# Flowline and Final Reclamation Inspection

June 28, 2017

Operator: BARRETT CORPORATION\* BILL - 10071

Inspection Photos  
Location Name: LOVELY #1  
API: 05-123-12684

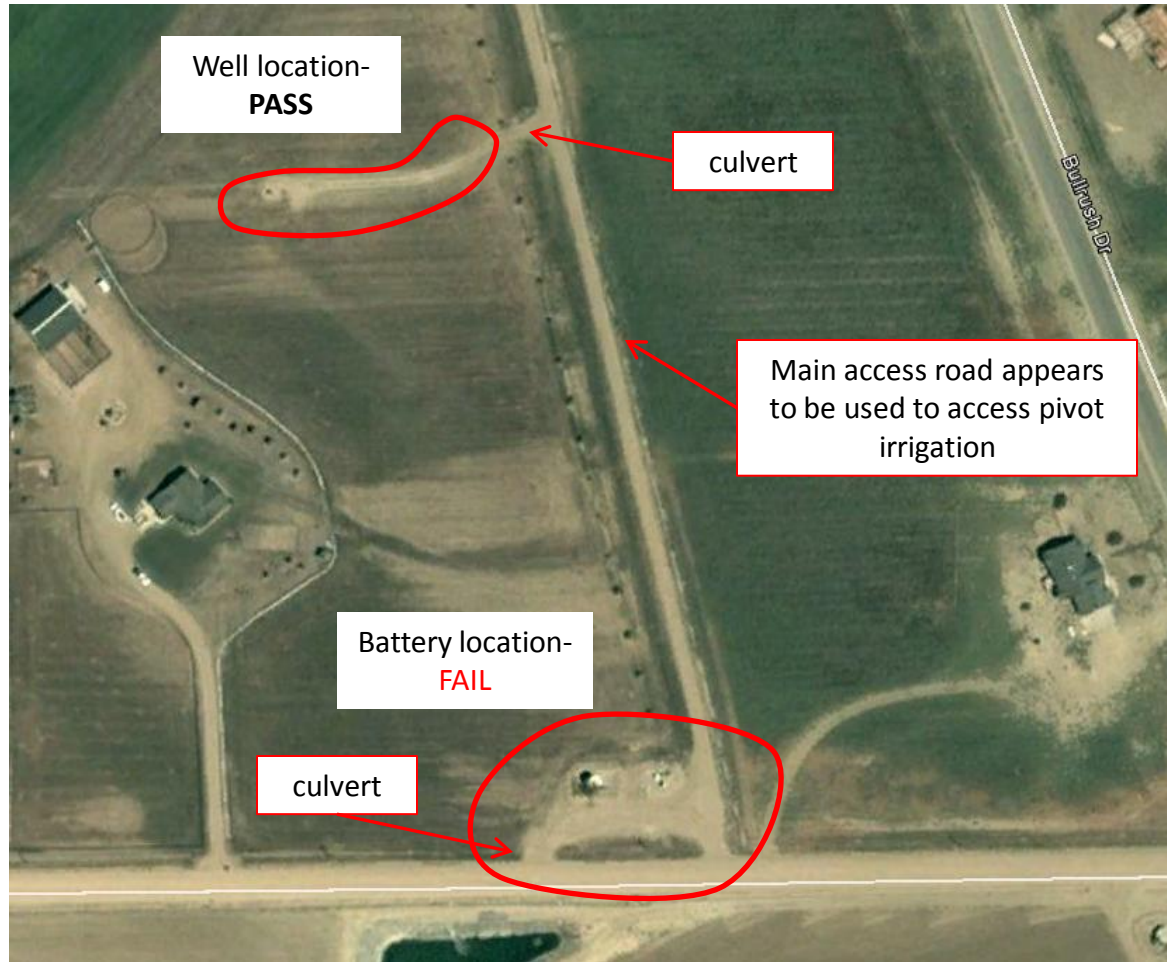
**Photo 1.** Google Earth aerial photo taken 6/26/2006 illustrating the battery location, access road, and well location. Well location appears to pass reclamation but a culvert remains. Battery location has not been reclaimed with several culverts but some of which may be needed because the main access road appears to be used to access a pivot irrigation field to the north.
